<b>REFERENCE:</b>	<b>TSB:</b> 23-038-25 <b>GROUP:</b> 23 - Body	<b>Date:</b>	October 22, 2025	<b>REVISION:</b>	—
<b>VEHICLES AFFECTED:</b>	<b>2025 (WS) Wagoneer / Grand Wagoneer</b> This bulletin applies to vehicles built on or after March 03, 2025 (MDH 0303XX) and on or before July 18, 2025 (MDH 0718XX) equipped with Wagoneer Badge With Flag (Sales Code MVA), Exterior Accents-black (Sales Code MHY) or Exterior Accents-Super Wagoneer (Sales Code MHX).			<b>MARKET APPLICABILITY:</b> <input checked="" type="checkbox"/> NA <input type="checkbox"/> MEA <input type="checkbox"/> SA <input type="checkbox"/> IAP <input type="checkbox"/> EE <input type="checkbox"/> CH <b>NOTE:</b> This bulletin applies to the North America market.	
<b>CUSTOMER SYMPTOM:</b>	Customers may comment on the following: <ul style="list-style-type: none"> <li>The hood nameplate (badge) does not match the other nameplates on the vehicle.</li> </ul> <p><b>NOTE:</b> The incorrect hood nameplate will be chrome, the other vehicle nameplates are black <b>Fig. 1</b>.</p>

**Fig. 1**  
Incorrect And Correct Nameplates

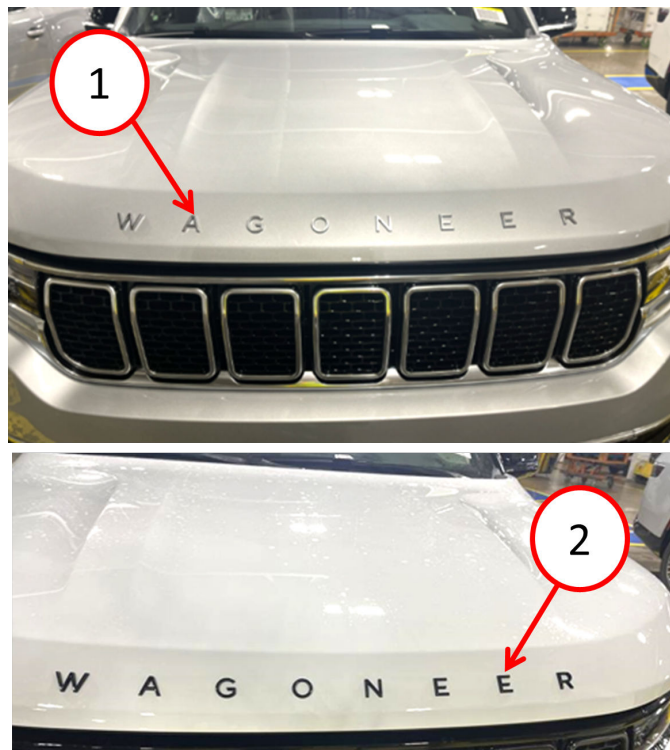
1 - INCORRECT Nameplate (Requires Replacement)  
2 - Correct Nameplate

- Inspect the color of the hood nameplate.
- Is the color of the hood nameplate chrome?
  - YES >>> Replace the hood nameplate. Proceed to [Step 3](#).
  - NO >>> Use Inspect LOP (23-01-18-9H) to close the active RSU.
- Apply a length of masking tape on the body, parallel to the top edge of the nameplate to use as a guide.
